FOREST FARM, CHIPPENHAM

OVERLAND EXCEEDANCE FLOW PLAN

APPENDIX P: LLFA Correspondence

From: Wilding, Ben <Ben.Wilding@atkinsrealis.com>
Sent: 09 January 2026 12:38
To: Steven Lecocq
Cc: MX0300 - Wiltshire LLFA; Farris Alkhatib
Subject: Re: Gleeson Land at Forest Farm, Chippenham - Drainage Queries

Figure 1

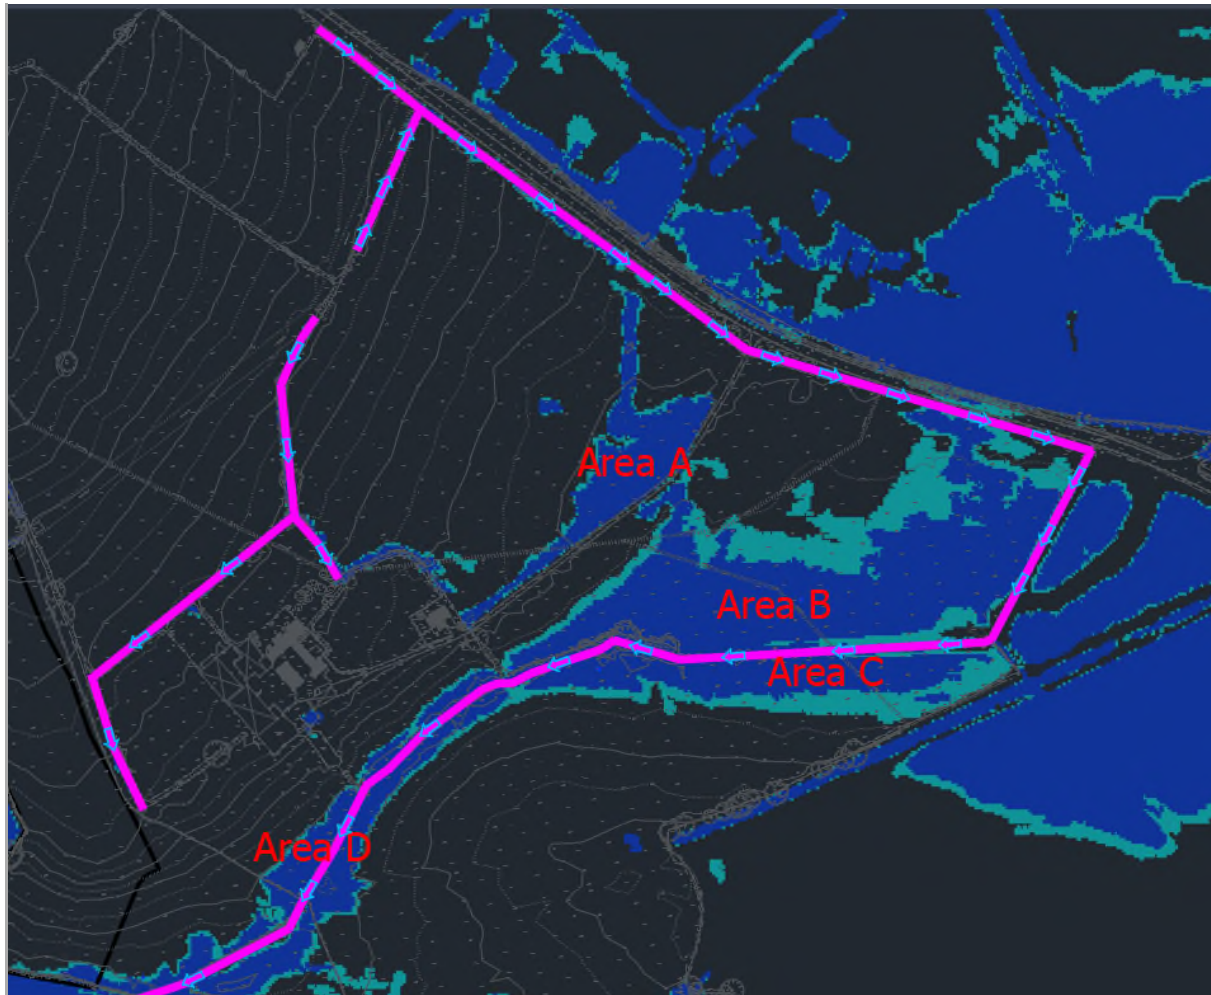
5.4	I have had a look at this on Scalgo, which is a tool we use to look at flow paths. It does not always pick up all ditches but it currently would indicate that there would be flow coming into Area A from adjacent land. I appreciate this may not be correct, but feel it would be worth in your report including site photos, cross sections and extents of the ditches you mention just so as it can be demonstrated that they do exist (and therefore so as to validate some of your statements made) Thanks for these comments, all of which are noted. We have a full topographic survey of the ditch demonstrating that it's there, so I trust this would be sufficient? Topo survey of the ditch would be sufficient - thanks for clarifying On the basis that the Area A did only drain itself and not have contributing flows from adjacent land (as I have indicated) I think this sentence may be missing the second half, but I trust it was going to say "On the basis that the Area A did only drain itself and not have contributing flows from adjacent land (as I have indicated), then this would be acceptable". Can you please confirm? Your suggestion is correct (sorry for the mistake in the comment) - Agreed

Meeting Note 09.01.26 – SL clarified with BW that it was the flow path circled in Figure 1 below that was being referred to, which BW confirmed. SL advised following this comment he went back out to site to confirm the extent and location of the ditch networks, which are indicatively shown by the thick magenta lines in Figure 2 below. The site visit identified a break in the ditches on the north western field boundary, however both SL and BW agree that this does not alter the conclusion that the flood risk in Area A is only contributed by the site itself. In relation to the flow path described in BW's comments above, noting the London Road ditch continues at this location (as evidenced by the Topographic Survey and site inspections and photographs) both BW and SL agree that the flood risk in Area A is only contributed to by the site itself. A photograph of upstream side of ditch culvert underneath the site access is contained in Figure 3 with the location of the photo shown by an X in Figure 1 below. These will be included within the FRA for clarity.
